**1 Products affected**

**2 Type of change**

Product Change Notification					PCN Fusedrawer 2		
owner	creation date	release date	released by	change order no	rev	page	D10-017-137
sariogar	21.09.2017	22.09.2017	buerglal	2013754	C	1 of 3

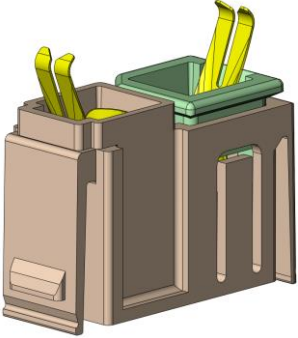
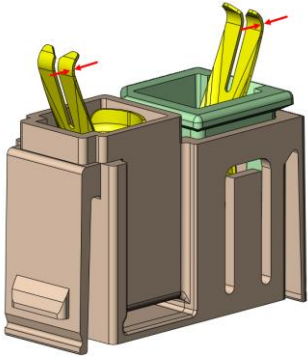
Old contact spring thickness 0.20 mm	New contact spring thickness 0.25 mm

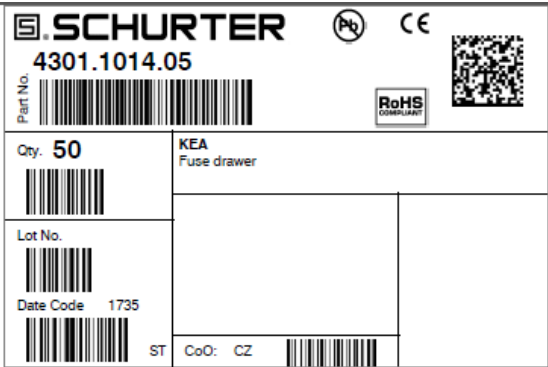
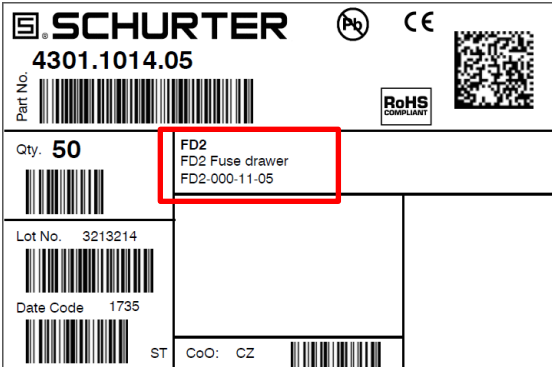
Old label	New label
	<p>Name and description adjusted. Configuration code added.</p>
